Notice of Allowability	Application No.	Applicant(s)	
	10/685,274	SCHMIDT, ALBERT LEO	
	Examiner	Art Unit	
	Darren W. Gorman	3752

EXAMINER'S AMENDMENT

Marked-up Drawings

FIG. 7

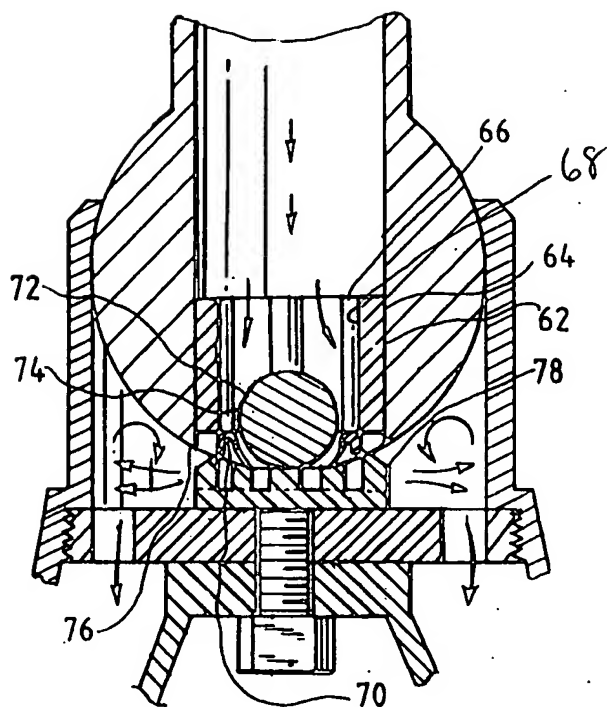
- Figures 7 and 8 must include reference number “68”, which designates the inner circumferential surface of the valve body as disclosed on page 11 of the specification. Please refer to the enclosed marked-up page 3 of 3, which indicates in red ink where reference number “68” should be located in Figures 7 and 8 of Applicant’s Replacement Sheet.
